RE: Planning Reference: 25/60234

A Large-Scale Residential Development (LRD) at this site of c.4.279 ha (gross) at Boreen Bradach, Kinnegad, Co. Westmeath. The main development site is bounded by Boreen Bradach Road (L-5014)/Bun Daire estate to the east/north-east, St Etchen's National School to the west and St Etchen's Court to the south. The proposed development will comprise a residential scheme of 129 no. houses along with childcare facility (c.261.3 sq.m). The development will include 2 no. 1-bed houses, 11 no. 2-bed houses, 97 no. 3-bed houses and 19 no. 4-bed houses, ranging in height from one to two storey and including detached, semi-detached and terraced units. Provision of vehicular, pedestrian/cyclist access from the L-5014 (Boreen Bradach Road) and associated upgrades to the local road. All associated site development works, including 263 no. car parking spaces (including 30 no. EV spaces), 330 no. cycle parking spaces. Provision of public and private open spaces, landscaping, boundary treatments, waste management areas, and services provision (including 2 no. ESB substations). All associated works required to enable this development including connection to the Uisce

Figure 2: Proposed Crèche Floor Plan illustrating internal bin and bike storage facility

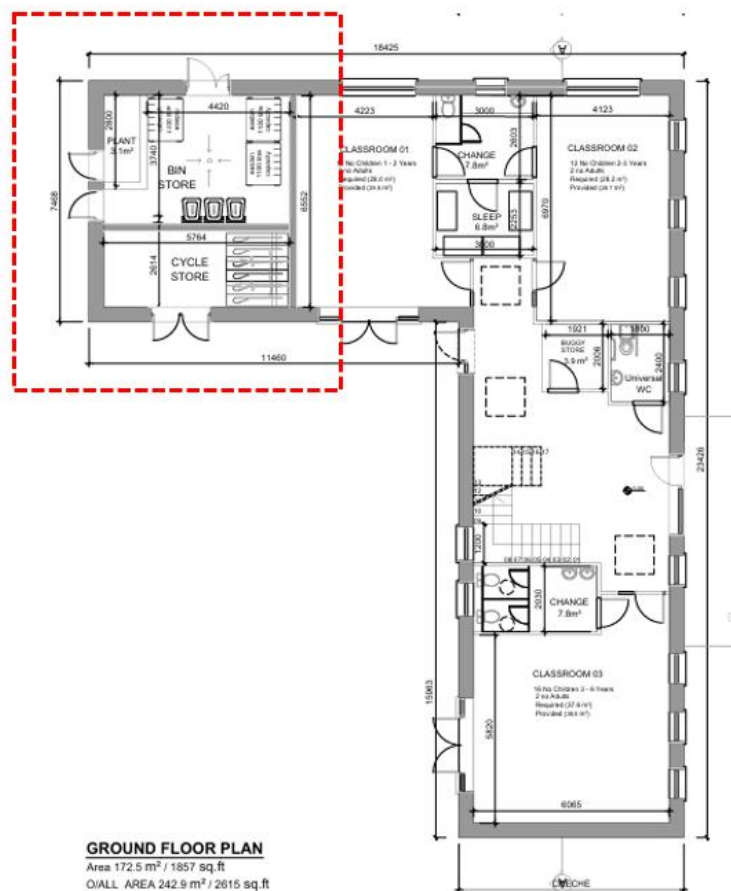
- ii. *The siting of the waste and bicycle storage structure serving the creche located on a prominent corner of the site addressing the new internal residential road and immediately abutting 2 no single storey dwellings (Type G) together with associated boundary treatment is inappropriate. Please submit revised design proposals relocating this service structure to a lesser prominent part of the site. Please note that all boundary treatments addressing the internal service road and Boreen Bradach should be a high-quality design and finish having regard to the sites prominent location.*

- ii. In response to the concerns raised, the waste and bicycle storage facilities serving the crèche have been relocated within the ground floor footprint of the crèche building. This ensures that such service functions are fully integrated into the building design, removed from the prominent corner of the site, and no longer positioned adjacent to the two single-storey residential dwellings (Type G). This revision mitigates any potential negative impact on the residential setting or streetscape and provides a more appropriate arrangement in line with best practice urban design principles.
